Records Already Publicly Available in ADAMS

Declaration of Paul Blanch

7. On September 27, 2014, I formally submitted my expert opinions to FERC related to the potential impact of the proposed Algonquin Incremental Market (AIM) pipeline expansion (FERC Docket No. CP14-96-000) on the safe operation of the Indian Point Nuclear Plant.

Figure 9: Sequence of top-view images of contour plots showing methane volume fraction from 1 to 8 minutes after release. Distances are in meters.

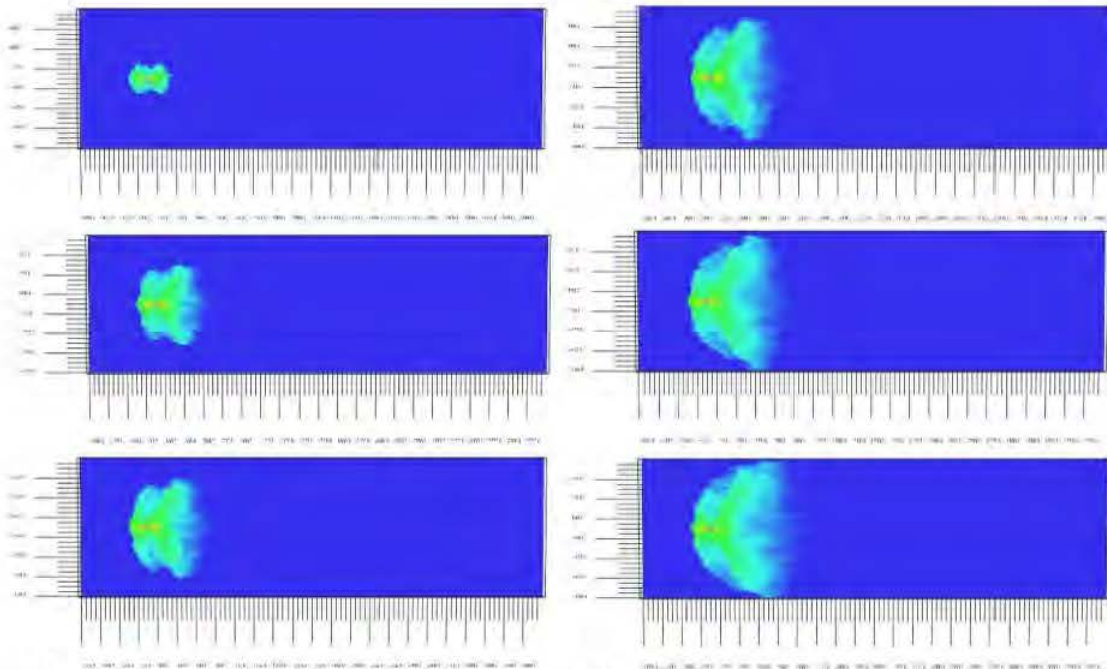
- Last sentence, second para, page 6 needs edit: "if it behaves as a dense gas which will greatly **extent** the time" **Corrected**
- Figure 9: please split into separate figures and note minute represented **Will separate Figure 9 with time noted.**
